OGN-SMD and OGN product family combined.

Product Change Notification					PCN OGN family consolidation		
owner	creation date	release date	released by	change order no	rev	page	D10-063-657
sariogar	03.03.2022	14.04.2022	schulejo	2023609	A	1 of 4

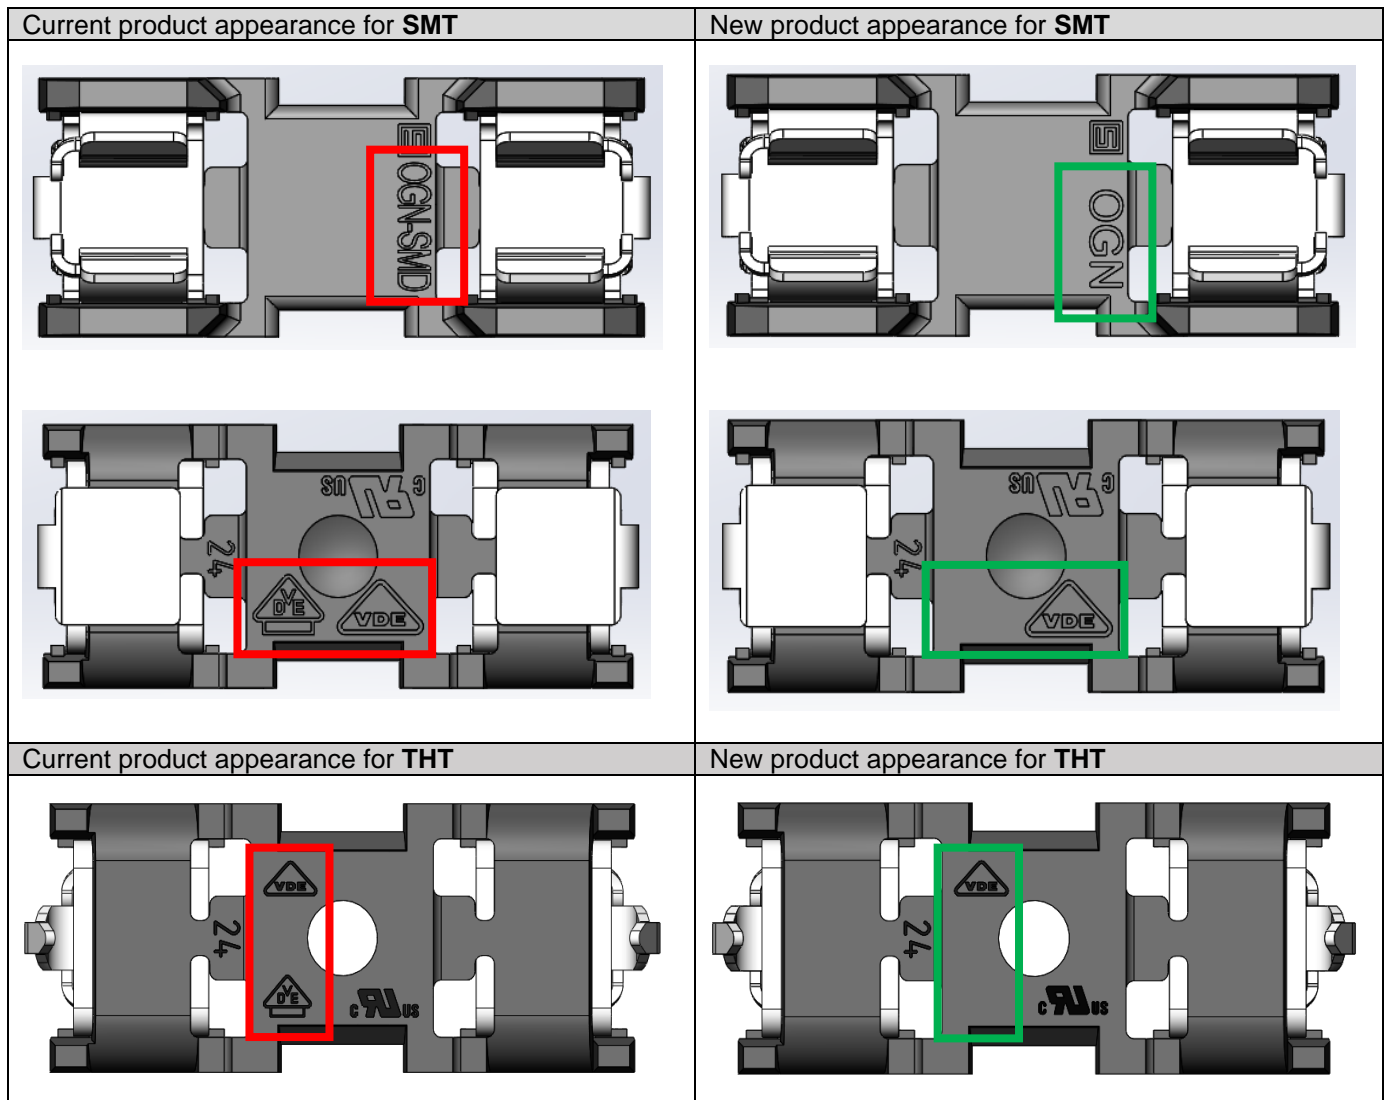
- Change of label
- Change of configuration code
- Change of type name
- Change of approval

Current label for SMT	New label for SMT
 <p>Current label for SMT showing P/N 0031.8221, Type OGN-SMD, and technical specifications: UL 500V / 16A, VDE 250VAC / 4W / 10A, VDE ÜG 500VAC / 4W / 16A. The label also includes RoHS, UL, and VDE compliance logos.</p>	 <p>New label for SMT showing P/N 0031.8221, Type OGN, and technical specifications: UL 500V / 16A, VDE 250VAC / 4W / 10A, VDE 500VAC / 4W / 16A. The label also includes RoHS, UL, and VDE compliance logos.</p>
Current label for THT	New label for THT
 <p>Current label for THT showing P/N 0031.8211, Type OGN, and technical specifications: UL 500V / 16A, VDE 250VAC / 4W / 10A, VDE ÜG 500VAC / 4W / 16A. The label also includes RoHS, UL, and VDE compliance logos.</p>	 <p>New label for THT showing P/N 0031.8211, Type OGN, and technical specifications: UL 500V / 16A, VDE 250VAC / 4W / 10A, VDE 500 VAC / 4W / 16A. The label also includes RoHS, UL, and VDE compliance logos.</p>

Current product rating	New product rating
<p>UL 500V / 16A VDE 250 VAC / 4W / 10A VDE ÜG 500 VAC / 4W / 16A</p>	<p>UL 500V / 16A VDE 250 VAC / 4W / 10A VDE 500 VAC / 4W / 16A</p>
Current configuration code	New configuration code
<p>OGN-140-11-0 OGNSMD-250-11-0</p>	<p>OGN-140-11-0 (OGN for THT) OGN-250-11-0 (OGN for SMT)</p> <p>All standard OGN-SMD parts will have the configuration code changed by removing "SMD". The first number of the configuration code indicates the mounting method.</p>
